FTT space envelop

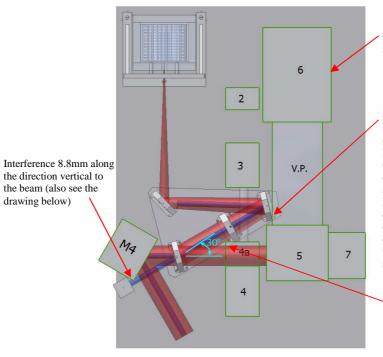
Green lines indicate the space envelop from NMT

No interference with the beam space envelop given by NMT, i.e. Ø95 mm beam @ 150mm height. However, should they use Ø110mm instead of Ø 95mm? I can move the fold mirror mount away from the AO beam a bit. But, this will shift the FTT camera housing very close to the edge of the optical table (the current distance is about 50mm, which may still not meet our satisfaction – for discussions).

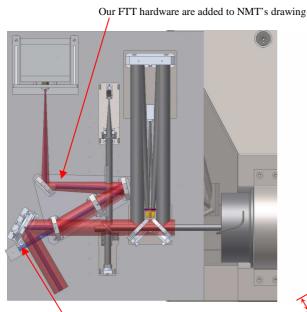
The lens mount does not have interference with their space envelop. However, our common base plate has. From their 3D drawing below, it has no collision with their hardware. It is needed to discuss this with NMT. If they insist the space envelop, we can cut the common base plate with a notch.

No interference with their hardware

22.8mm (can we ask for 10mm from NMT to get rid of the 8.8mm interference?)

8.8mm (amount of interference with the M4 space envelop)
